Our Case Number: ACP-322958-25

Re: Athlone link road phase 2. Proposed link road, joining the Crescent Junction (R915) to Southern Station Road Junction
Athlone, County Westmeath

Observation on a Strategic Infrastructure Development Application

Air Quality Levels at Athlone Civic Centre & Library, Co. Westmeath

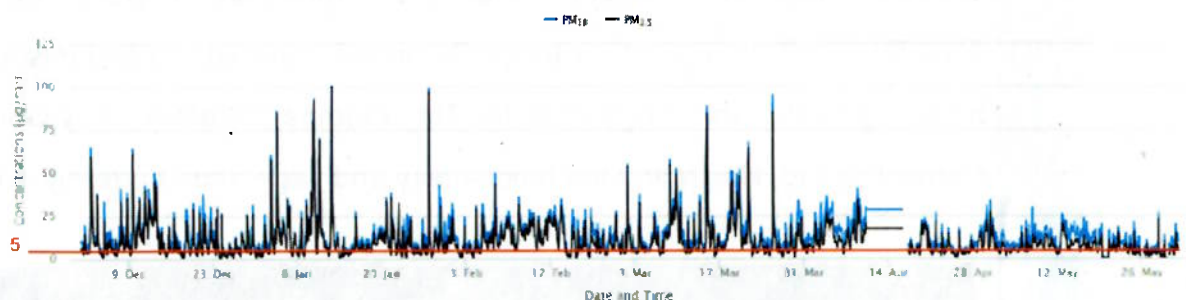
The Athlone Air Quality Monitor is located less than 100m from the proposed site. The dataset, publically available, gives an annual average of $8.63 \mu\text{g}/\text{m}^3$ for particulate matter in the area from June 2024 to May 2025. This is above the World Health Organisations safe guidelines of $5 \mu\text{g}/\text{m}^3$.

See figure indicating levels across a 6 month period with $5 \mu\text{g}/\text{m}^3$ highlighted.

The data also shows that the daily average exceeded the WHO recommended limit of $15 \mu\text{g}/\text{m}^3$ on a number of days in the year.

Figure 2.13: Example of a street that is hostile to pedestrians and cyclists (especially after dark). The unwillingness of people to interact with this type of environment will serve to undermine the viability of public transport services.

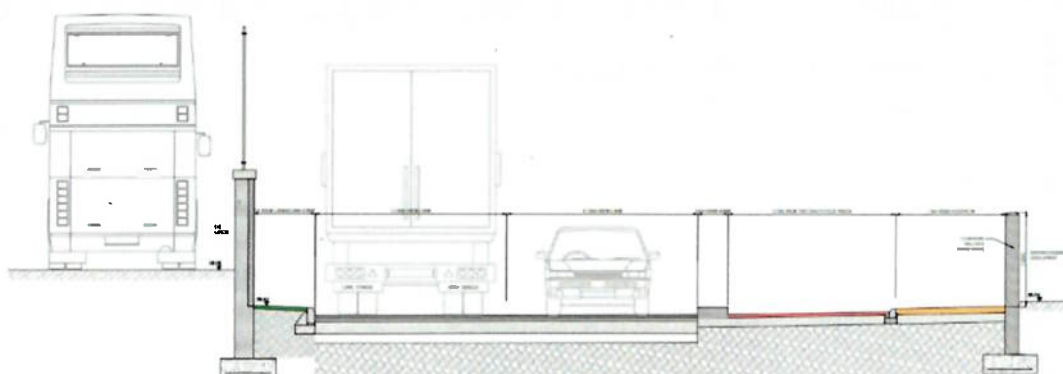
The cross section of the road as outlined in *Pl2_Typical_Cross_Section* is similar to Figure 2.13 on page 22 of DMURS which illustrates an example of a street that is hostile to pedestrians and cyclists (especially after dark). See below:

Proposed Cross section above.
